## SPANGDAHLEM AB WING CONFERENCE SVTC Q&A

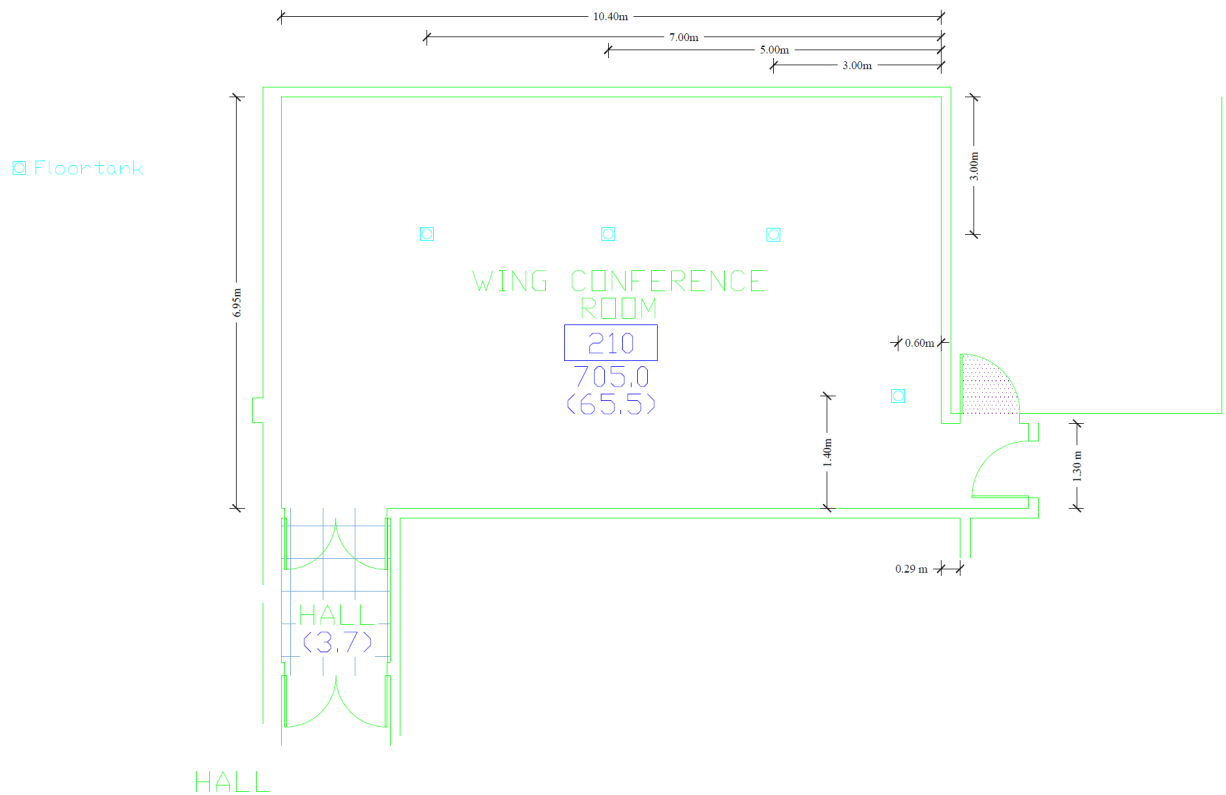
g. The requirement states' the following, fTable.legs.must.be.designed.to.align.directly.over.floor\_based.cable.outletsfj. Can we get the answers to the following?

i. Question: What are the dimensions of the floor based outlets?

1. Answer: L 400 / W 400 / H 150 mm for the three units located beneath the table. L 300 / W 300 / H 150 mm for the unit at the lectern.
